Section 10

Modifications

Hardware Installation of Reset/Power On LED

DD+DIS034.99E

With new Power Supply PCB

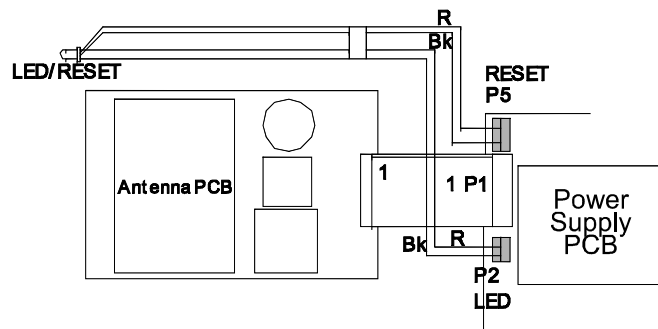
1. Make sure that the cables of the reset/power on LED are plugged into the Power Supply Board in the way shown beside.

With old Power Supply PCB

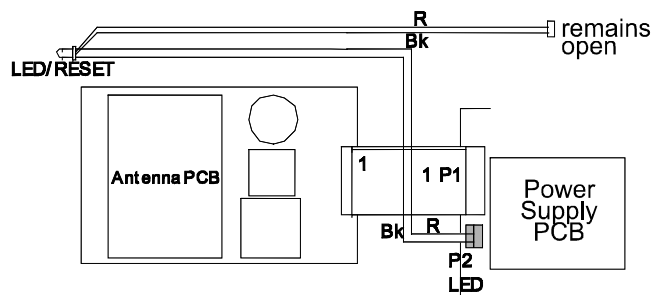
2. Older ID-tablets do not have a **P5** connector on the Power Supply PCB. Therefore the reset function is **not** available with those machines.
